# Service Bulletin

**SUBJECT:** Service Update for Inventory and Customer Vehicles  
Power Liftgate Inoperable  
Expires with Base Warranty

**MODELS:** 2015 Cadillac Escalade, Escalade ESV  
2015 Chevrolet Suburban, Tahoe  
2015 GMC Yukon, Yukon XL  
Equipped with Power Liftgate (TB5/TC2)

3981547

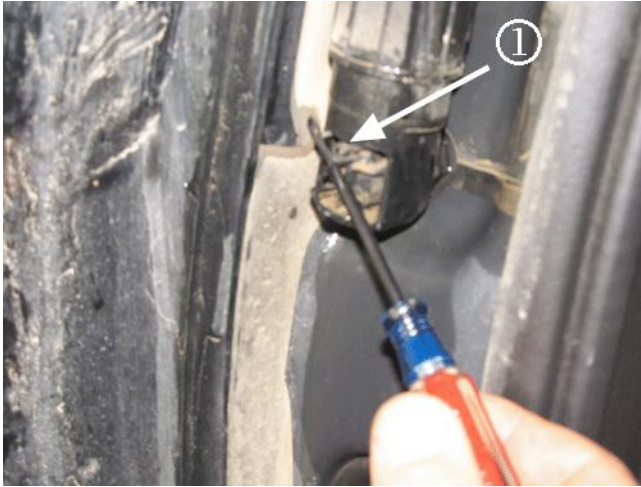
1. Remove the liftgate upper trim finish panel (1). Refer to *Liftgate Upper Trim Finish Panel Replacement* in SI.

3981551

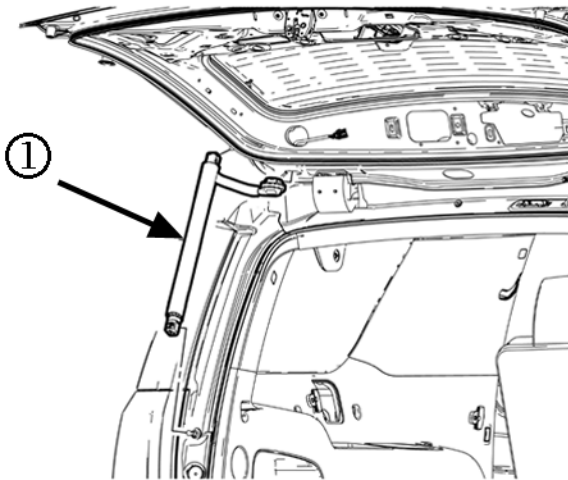
4. Using a small flat blade screwdriver, or similar tool, release the actuator retainers/clips (1).
